Aboni Knitwear (New Shed)

169-171, 195-196, Tatulzhora, Hemayetpur, Savar, Dhaka

3rd February 2019

Observation

Inconsistency in roof bracing system

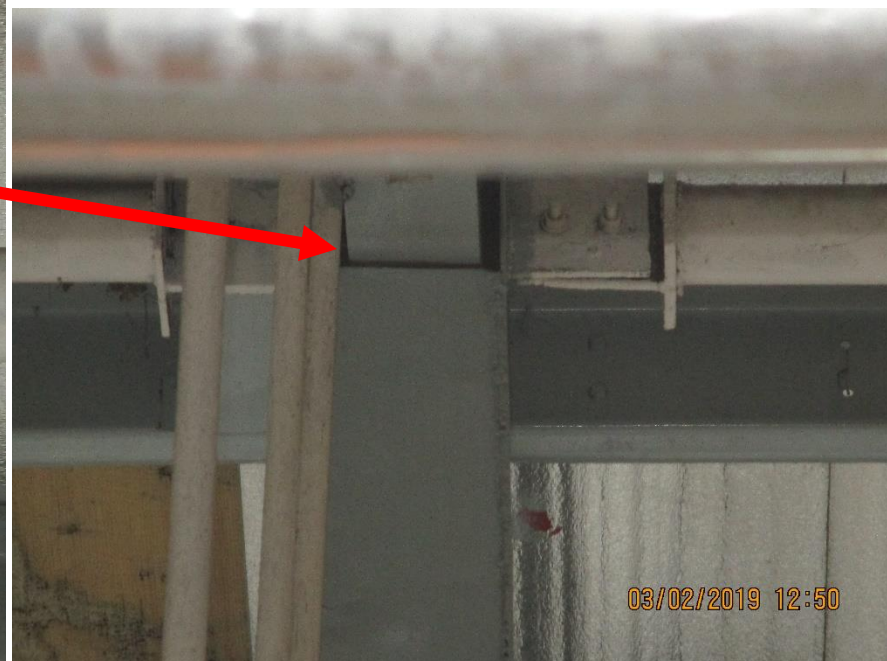
Inconsistency observed in roof bracing system. Building engineer is required to review the existing bracing system for the lateral stability.
